GOLD STANDARD VERIFICATION REPORT

For: CO2 Balance UK Limited

REPORT NO.:
GS11046-MP1
GS11047-MP1
GS11048-MP1
GS11049- MP1

Related activity	Verification
Project Title (s)	GS1247 VPA 266 - Burkina Faso Safe Water GS11046 GS1247 VPA 267 - Burkina Faso Safe Water GS11047 GS1247 VPA 268 - Burkina Faso Safe Water GS11048 GS1247 VPA 269 - Burkina Faso Safe Water GS11049
Project ID (s) (i.e.: GS-ID)	GS11046 GS11047 GS11048 GS11049
Project Type	Energy Efficiency – Domestic (Borehole)
PoA Title (if applicable)	Improved Kitchen Regimes Multi-Country PoA
POA ID (if applicable)	GS1247

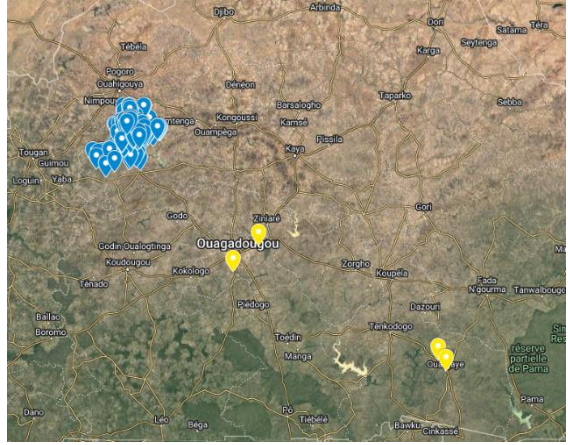
Rule	Assessment Question	Findings/Comments	Developer Response
		2) PD shall submit the photos of the latest installation for all locations with name and title for identification.	2. PD has submitted a sample of rehab confirmation forms in PDF version, which contains photos and names of boreholes for identification. PD has also updated MR to include some rehab photos.
	Rd 2	<p>PD has updated the MR with the GPS co-ordinates of the boreholes. #Closed.</p> <p>PD has submitted rehab confirmation PDF named as rehabCF for each of the VPA, the document also has the signature and photograph. The information provided is found to be satisfactory by the assessment team.</p> <p>However, the photographs of the rehab could not be found in the MR. #open.</p>	PD has submitted PDFs of first and last RehabCF from each VPA which contains photos of the boreholes.
	Rd 3	PD has submitted a separated PDF of rehab photos, therefore, the finding stands closed. #CLOSED
